Planning Commission
 Preliminary Plan
Hunters Ridge
 Wadsworth Township

Meeting:	March 5, 2014	Sublots:	8
App. No.:	008-2014-PP	Zoning:	R-3, Single-Family Urban Residential
Applicant:	Aaron & Jennifer Link	Utilities:	Central sanitary sewers and wells
Engineer:	Tony Burgoyne, P.E.	School Dist.:	Wadsworth City
Parcel No.:	038-17B-21-030	Reviewer:	Rob Henwood
Site Area:	26.543 acres

Hunter's Ridge
 Preliminary Plan
 App. 008-2014-PP
 Wadsworth Township

HORIZONTAL CONTROL/SCHEMATIC PLAN

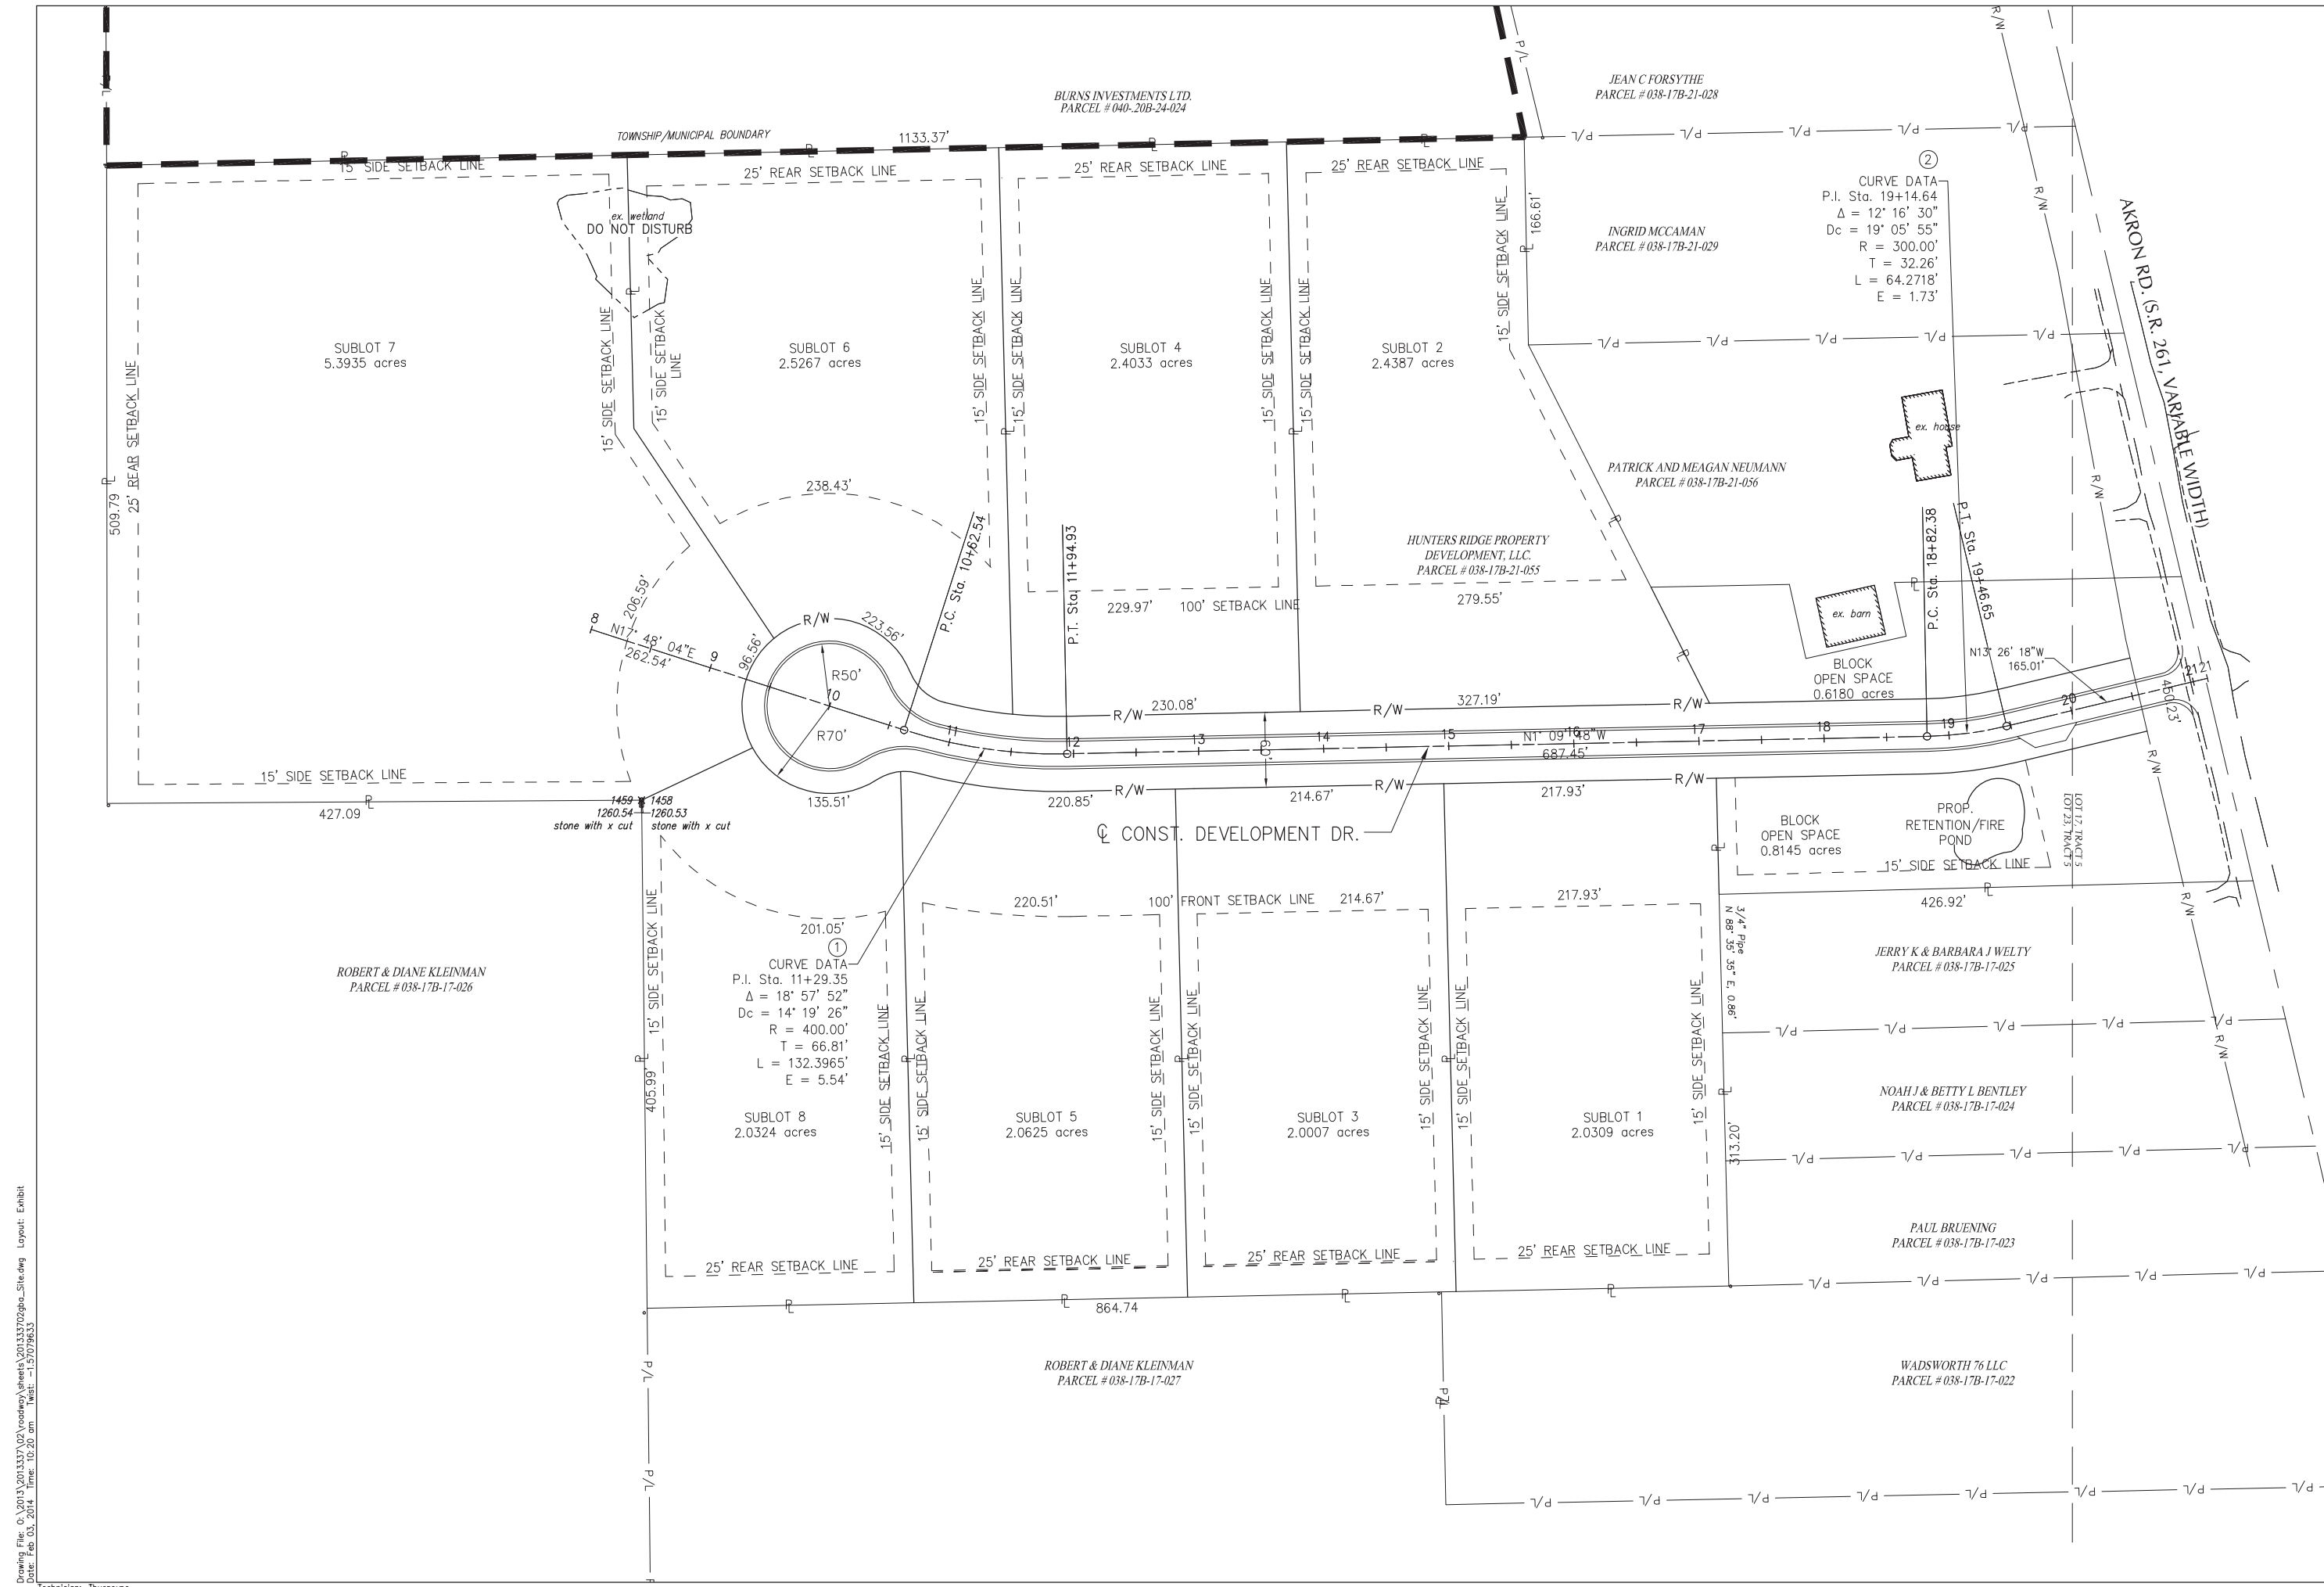
8. The following required data/information was not provided on or with the Preliminary Plan (Regulations section references are included and *italicized text* indicates required action):
 - a. Names, addresses, and telephone numbers of... engineer, and/or surveyor. § 404(C)(2)a.2. ***Add contact information for engineer and surveyor.***

- b. Total number of lots, area of lots and blocks..., area of public roadways... and total area of the subdivision. § 404(C)(2)a.7. **Add subdivision summary information.**

- c. Ground elevations of the subdivision at two-foot contour intervals. §§ 404(C)(2)b.5 and 404(C)(2)d.1. **Add contours.**
- d. Existing generalized natural features: including soils [and] streams. § 404(C)(2)b.7. **Add soils and streams.**

- e. Blocks shall be designated with a letter and in alphabetical order. § 404(C)(2)c.1. **Label Open Space Blocks as Blocks A and B.**
- f. Proposed streets identified by name or by letter designation. § 404(C)(2)c.5. **Label streets by name or letter designation.**

- g. Approximate location of storm and sanitary sewers and water lines. § 404(C)(2)c.1. **Show locations for storm and sanitary sewers and water lines.**

- h. Fire pond location and associated easements for access. § 404(C)(2)c.15. **Show fire pond access/maintenance easement.**
- i. Wetlands –The developer shall contact in writing the applicable U.S. Army Corp of Engineers District Office (USACE) regarding the proposed subdivision, and shall submit such correspondence to the Medina County Planning Commission (MCPC) as a condition of Preliminary Plan approval. § 404(C)(2)c.15. **Submit USACE correspondence.**

- j. All related watershed boundaries, indicating in which watershed the subdivision is located.... This may be presented as a map insert on the same page. § 404(C)(2)d.4. **Add watershed boundaries.**

PROPOSED DRIVE FULL DEPTH SECTION
N.T.S.

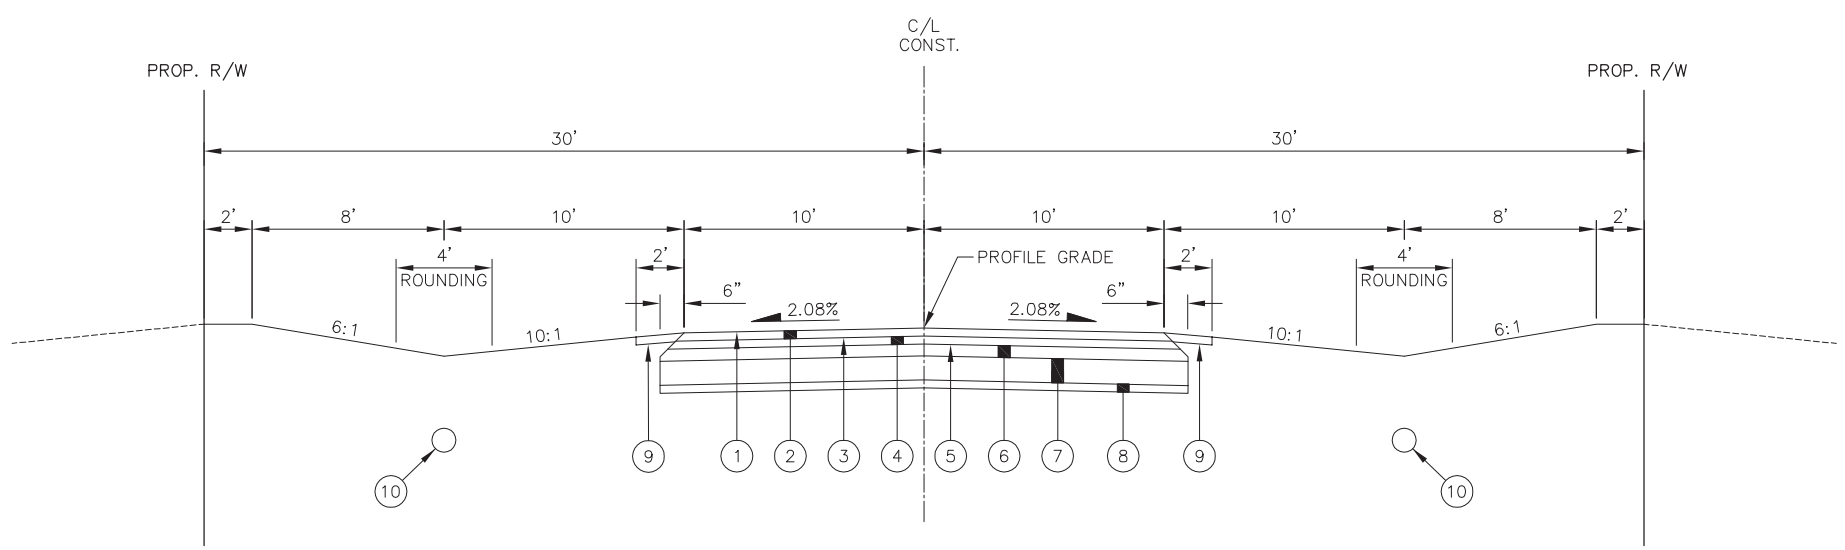
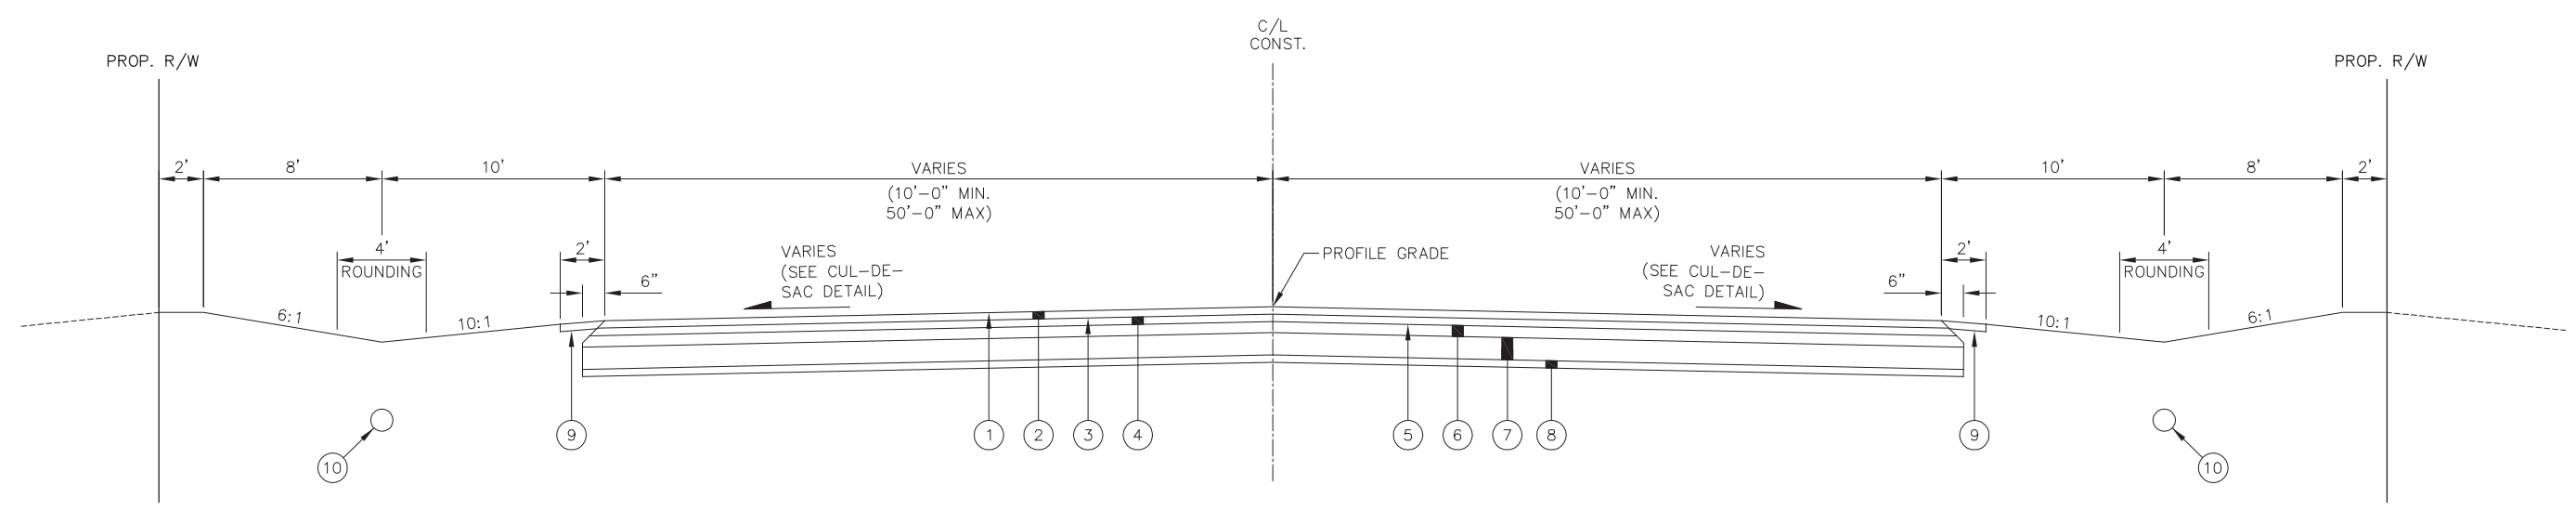
1. Clarify the project description. It shows a drive with private utilities.
2. Include contact numbers for the developer and the engineer.
3. See Subdivision Regulations for Preliminary Plan requirements.
4. See MCE "Item 405 Special Residential" Typical Section for correct section, details, and specifications.
5. Drainage maintenance fund will be required.
6. Provide 12 foot utility easements.

1. Address the issues raised by the MCE as follows:
 - a. Clarify the project description.
 - b. Correct the typical section, details, and specifications.
 - c. Provide 12 foot utility easements.
2. Demonstrate an approved ODOT permit for the proposed subdivision street.
3. Add language to the HOA documents allowing access to the open space blocks.
4. Add language to the HOA documents establishing the property owner's responsibilities regarding the wetland located on Sublots six and seven. Include language reflecting those responsibilities on the deeds for these sublots.
5. Submit evidence demonstrating no mine activity is documented on the subject site.
6. Provide all missing data specified in the staff comments.
